OIL CONSERVATION DIVISION
1220 South St. Francis Dr.
Santa Fe, NM 87505

Form C-103
Revised July 18, 2013

SUN STATE 01

P&A PROCEDURE

Proposed Wellbore

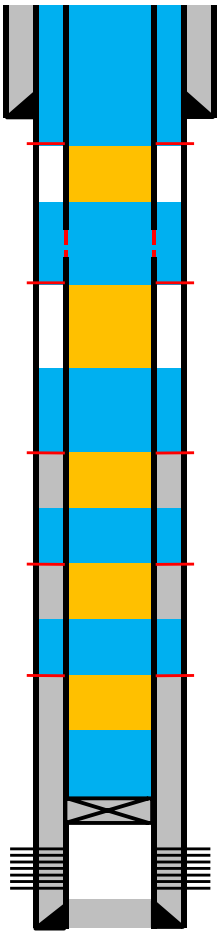
Created By	Condition	Condition Date
loren.diede	Notify the OCD inspection supervisor via email 24 hours prior to beginning Plug & Abandon (P&A) operations.	8/21/2026
loren.diede	Submit Cement Bond Logs (CBL) prior to submittal of C-103P.	8/21/2026
loren.diede	For Orphan wells OCD requires a photo and the GPS coordinates of the P&A marker to be included with the C-103P subsequent P&A report. The API# on the marker photo must be clearly legible.	8/21/2026
loren.diede	OCD has determined that this well IS NOT within the LPCH restricted area and that an above-ground P&A marker is required.	8/21/2026
loren.diede	Modify the top of the Plug 4 (7 Rivers/Yates) to 1450' to cover the B Salt. AND modify the bottom of Plug 5 (Anhydrite) to 1270' to cover the T Salt.	8/21/2026
